Access Compliance Report

Public Rights-of-Way

Intersection ID: 14987	Main Street: HERMITAGE_RD	Cross Street: MORAVIAN_LN	Location: NE
ADA ID: A7FFCEC3C3FA	Ramp Type: Perp	Initial Pass/Fail: Fail	Overall Compliance: No
Severity Score: 35			
Codes/Mitigation Info/Possible Solution		Field Measurements/Component Compliance

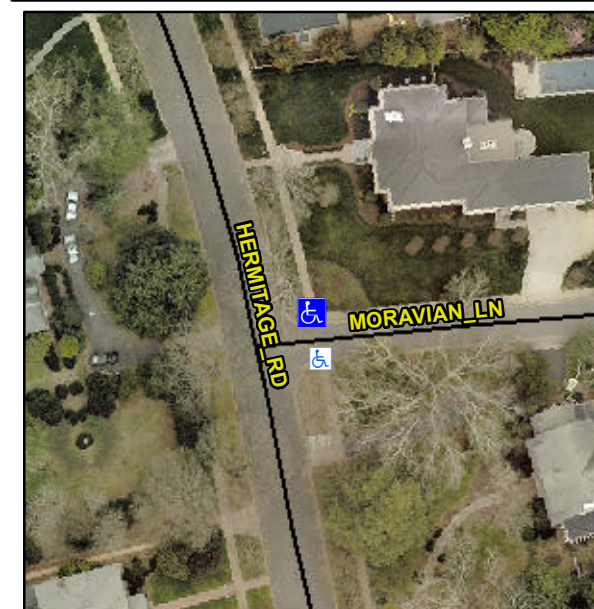
R304.5.1, R304.2.2, R304.5.3

Compliance	Description	Data	Compliance	Description	Data
N/A	Ramp Length (in)	54.0	No	Ramp Slope (%)	14.9
No	Ramp Width (in)	42.0	No	Ramp XSlope (%)	2.3
N/A	Flare Type LT	N/A	N/A	Flare Type RT	N/A
N/A	Flare Slope LT (%)	N/A	N/A	Flare Slope RT (%)	N/A
N/A	Flare Traversable LT?	N/A	N/A	Flare Traversable RT?	N/A
N/A	Landing Length (in)	N/A	N/A	DWS Provided?	N/A
N/A	Landing Width (in)	N/A	N/A	DWS Contrast?	N/A
N/A	Landing Slope (%)	N/A	N/A	DWS Length (in)	N/A
N/A	Landing X Slope (%)	N/A	N/A	DWS Full Width?	N/A
N/A	Landing Curb? (Y/N)	N/A	N/A	DWS Offset (in)	N/A
N/A	Shared Landing?	N/A			
N/A	Gutter Ponding?	Yes	N/A	Gutter Slope (%)	N/A
N/A	Gutter Lip Ht (in)	N/A	N/A	Gutter X Slope (%)	N/A
N/A	Painted X Walk1?	No	N/A	Painted X Walk2?	N/A
	X Walk 1 Direction	To S		X Walk 2 Direction	N/A
N/A	X Walk 1 Width (in)	N/A	N/A	X Walk 2 Width (in)	N/A
	X Walk 1 Slope (%)	0.0		X Walk 2 Slope (%)	N/A
	X Walk 1 X Slope (%)	2.2		X Walk 2 X Slope (%)	N/A

Remove & Replace Entire Ramp.
